KETCHIKAN, ALASKA
WATER STREET

REHABILITATION / REPLACEMENT OF OFF SYSTEM CITY BRIDGES
PROJECT NO BR-000S(735)~69534
68738 WATER STREET TRESTLE #2 REPLACEMENT - REIMBURSABLE

AS-BUILT SET

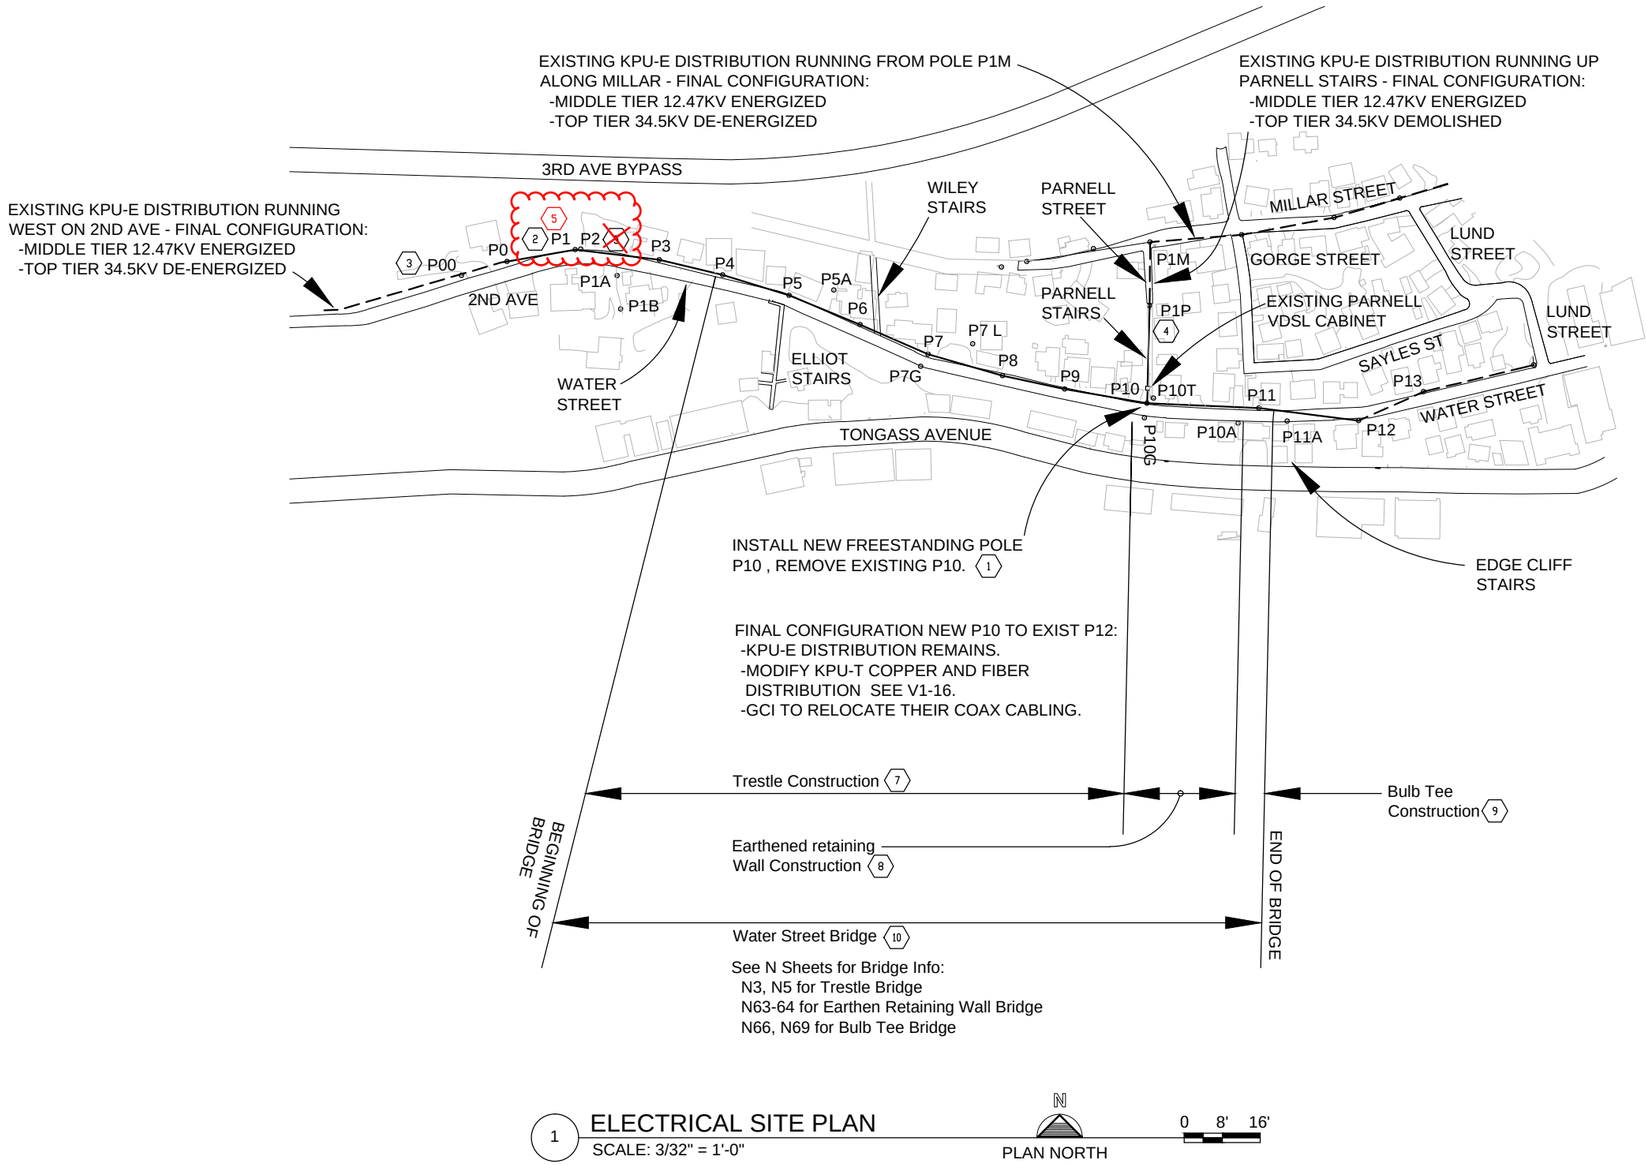
Pole P00 is mentioned in drawing U03 as install new crossarms, insulator, disconnect middle tier 12.47kv between Pole 00 and P1. General note C on U03 states Install new deadends and jumpers on P00. More details are needed for Pole 00.

P00: The new deadend crossarm and its guy (similar to existing Pole P3 guy installation) are installed on the middle tier of the pole. The deadend crossarm is install per Sheet U44, Detail 2.

Guys (662-2.07) are installed with the materials per the approved 662 'Guy and Anchor' submittals and KPU Standard E1 and F1 series drawings.

STATE	YEAR
ALASKA	2015
SHEET NUMBER	TOTAL SHEETS
U09	U56

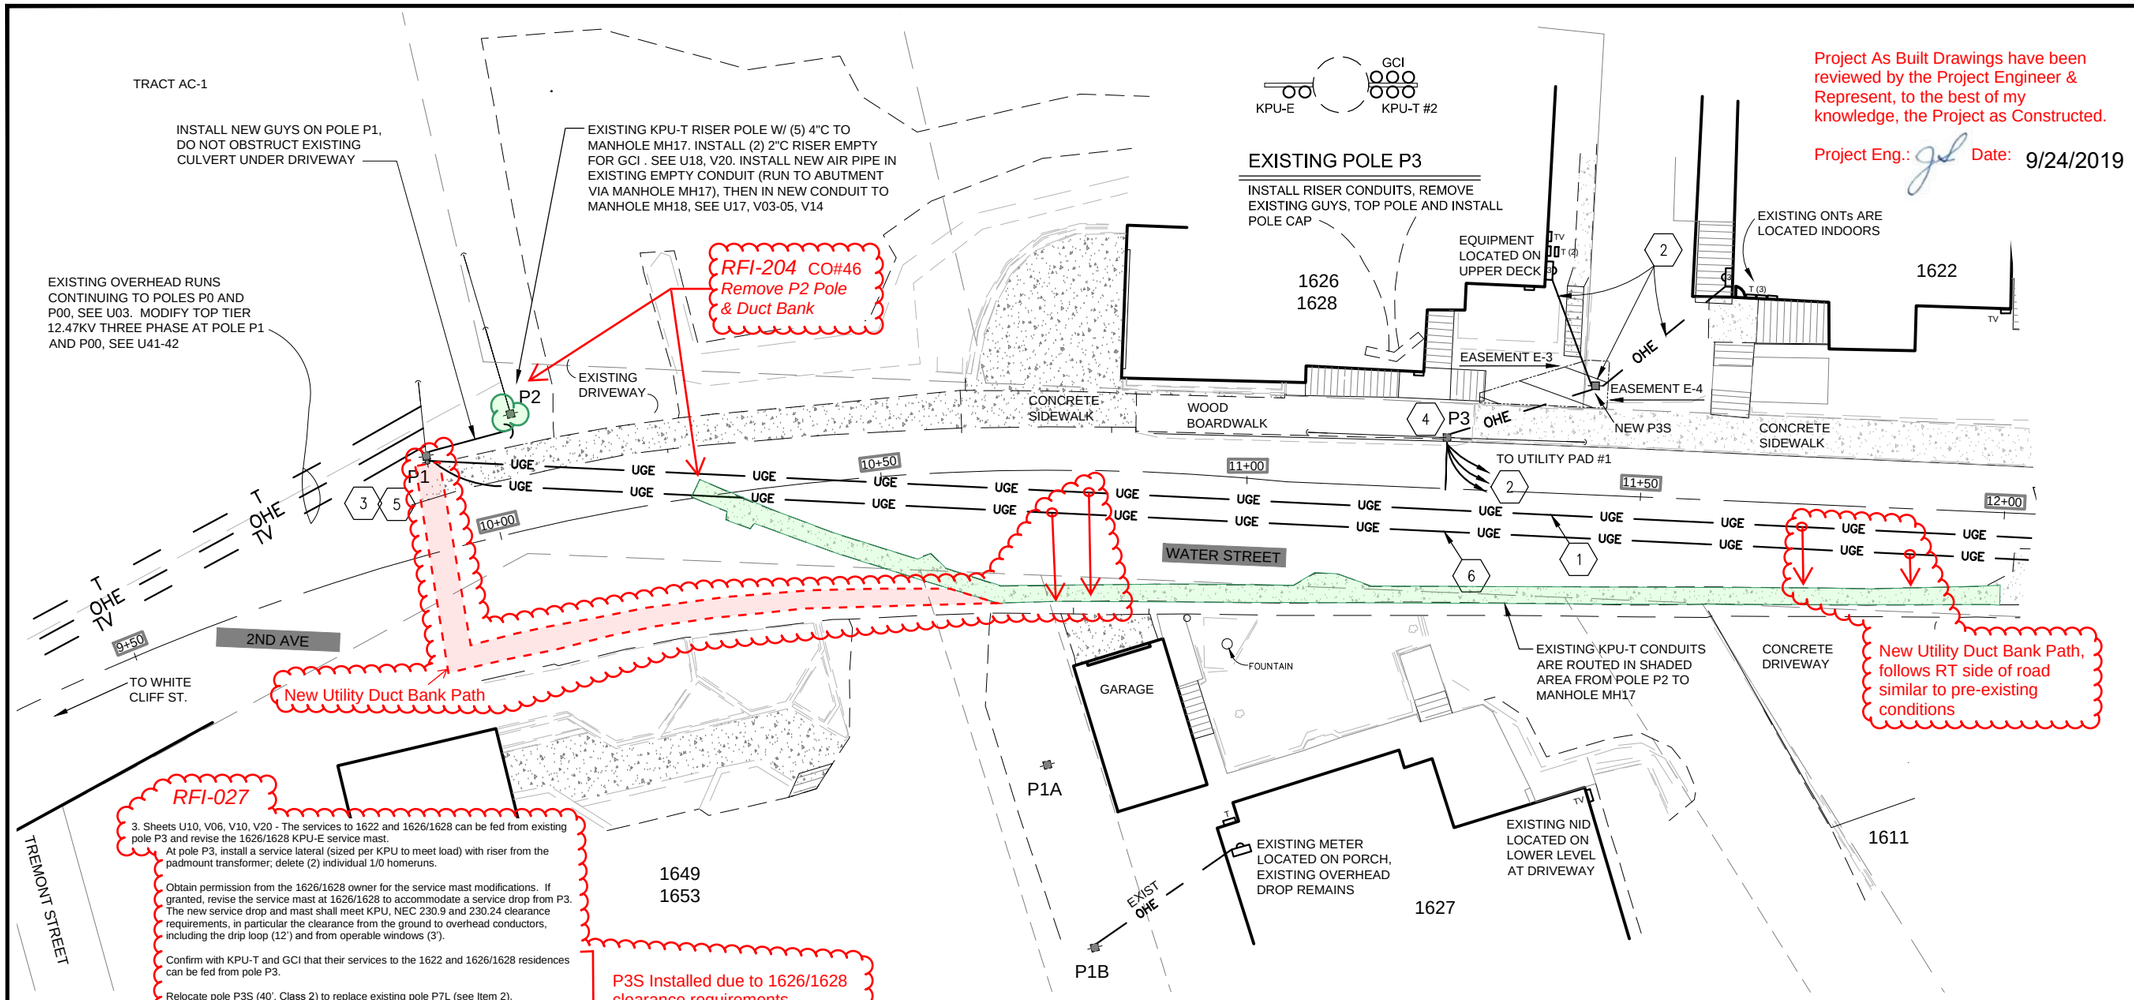
3. Sheets U10, V06, V10, V20 - The services to 1622 and 1626/1628 can be fed from existing pole P3 and revise the 1626/1628 KPU-E service mast.
